## INDEX TECHNICAL SERVICE BULLETIN

**IMx® (60)**

SUBJECT:  
**WorldWide Upgrade of IMx® System Software to revision 6.0**

TSB#: **60-040A**

**Figure 3**  
**ASIC CPU Cable Routing**

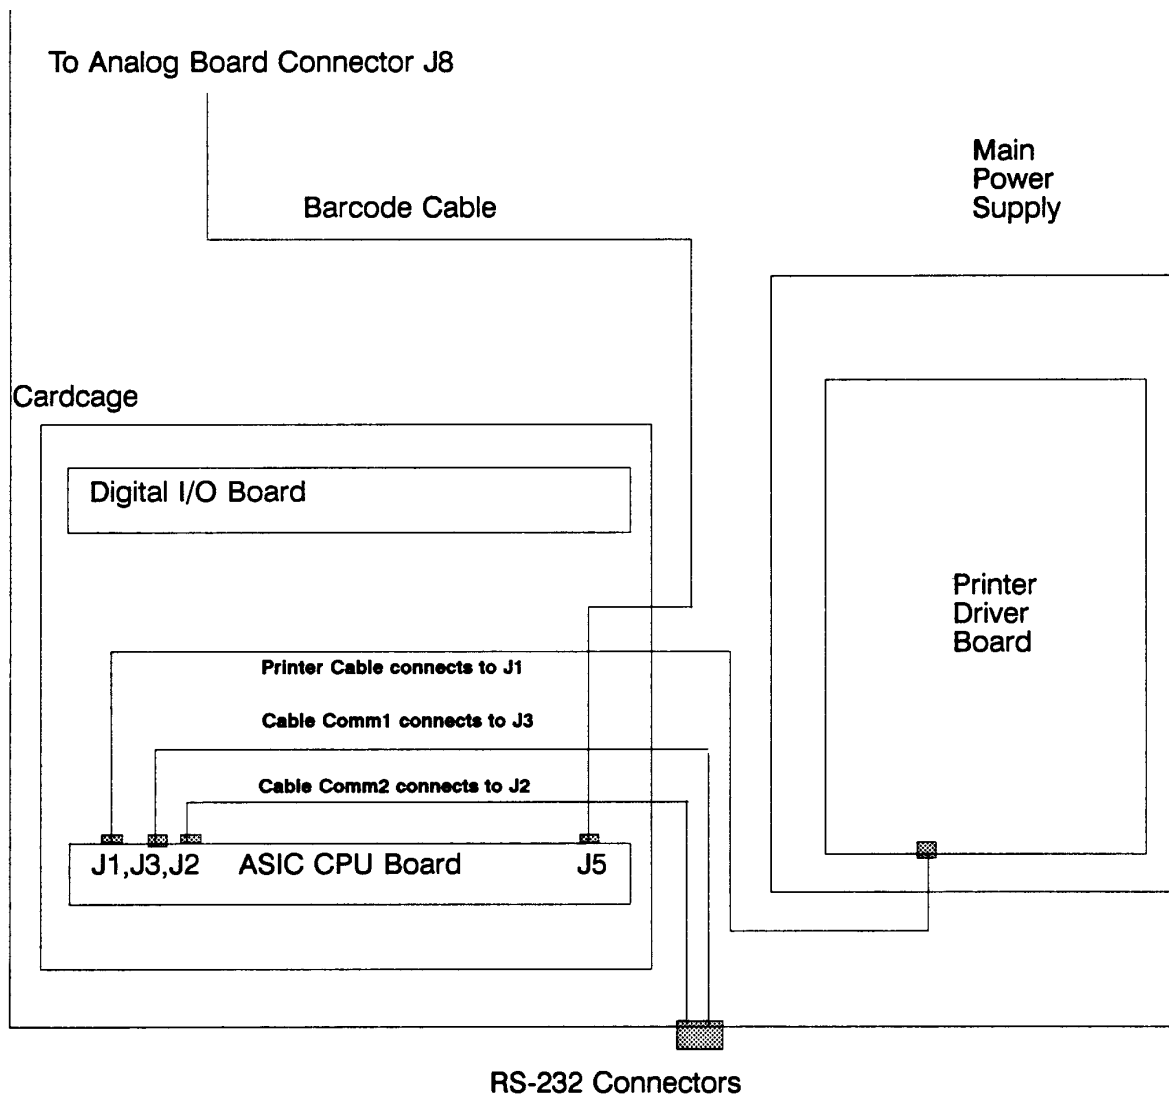
Connect the new RS-232 Cable and bracket assembly to the IMx base where the old one attached. Fold the cables so that the routing will travel up the right side of the card cage and along the top of the boards in the cage. Connect the cable ends to the appropriate connectors on the ASIC CPU Board. Route the cabling neatly since the cardcage top cover will be placed over these cables. Refer to Figure 3 for cable routing.

**Figure 4**  
**Novram orientation on ASIC CPU/MEMORY Board**

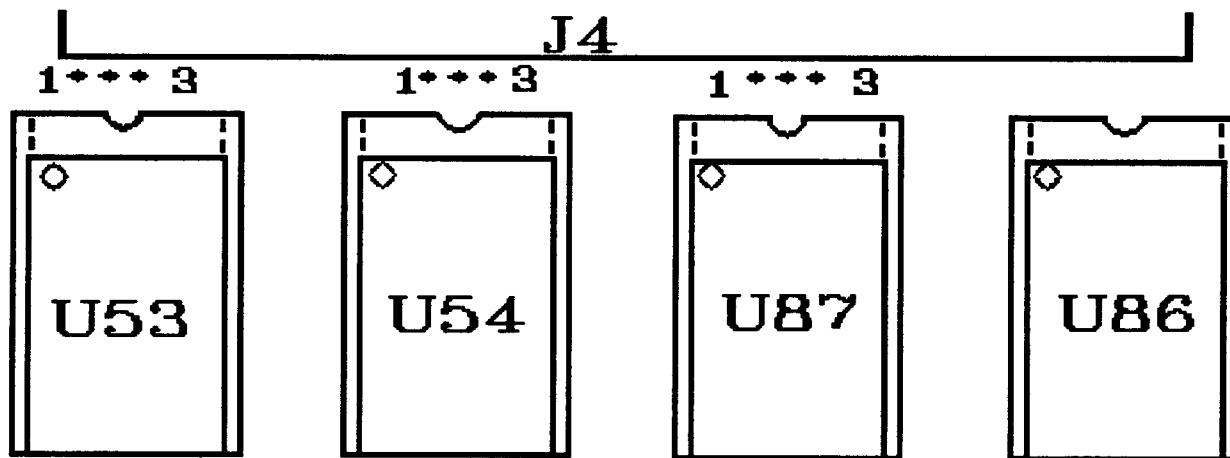
The ASIC CPU/MEMORY Board has four 32 pin sockets on board that the NOVRAM (U53, U54, U86, and U87) are placed in. The NOVRAM are 28 pin devices that are oriented as shown in the diagram below (Figure 4).
